Work Order ID 127256

Item Name: Support

D5124-1TRN FWD SUPPORT

WORK ORDER NON-CONFORMANCE / UPDATE

SECTION B-B

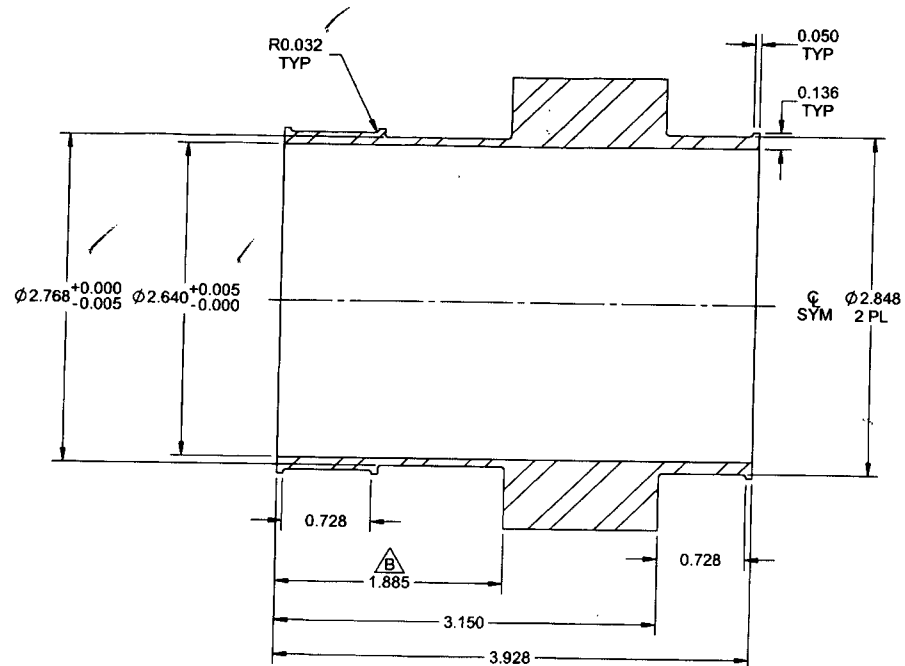
Root Cause	Date	Step	Qty	Description of work order update or non-conformance	Initial Chief Eng	Action Description	Sign & Date	Verification	QC Inspector
Design	14.12.17	100	1	DIM 3.928 (B3-2) IS ACTUALLY 3.905. RL offset was not Rechecked by Post Machy/ No Reverification. Prelim	A.P. 14.12.17	ACCEPTABLE. NO STRENGTH REDUCTION AS AND NO INSTALLATION ISSUES.	SL 14-12-17	OK 14/12/17	S 15/01/18
Doc/Data									
Equip/Tooling									
Handling/Pre									
Material									
Operator									
Offset/Setup									
Process									
Supplier									
Training									
Transport									
Unapproved

Work Order: <u>127256</u>	DISPOSITION Rework <input type="checkbox"/> Scrap <input type="checkbox"/> Use-as-is <input checked="" type="checkbox"/> Suspected Unapproved <input type="checkbox"/>	AGAINST DEPARTMENT/PROCESS			
Part No. <u>D5124-1TRN</u>		Skid-tube <input type="checkbox"/>	Crosstube <input type="checkbox"/>	Water Jet <input type="checkbox"/>	Engineering <input type="checkbox"/>
NCR No. <u>15-4643</u>		Machining <input checked="" type="checkbox"/>	Small Fab <input type="checkbox"/>	Prod. Eng. Coord. <input type="checkbox"/>	Quality <input type="checkbox"/>
		Thermoforming <input type="checkbox"/>	Finishing <input type="checkbox"/>	Rec/Store/Packaging <input type="checkbox"/>	Other <input type="checkbox"/>
		Large Fab <input type="checkbox"/>	Composite <input type="checkbox"/>	Supplier <input type="checkbox"/>
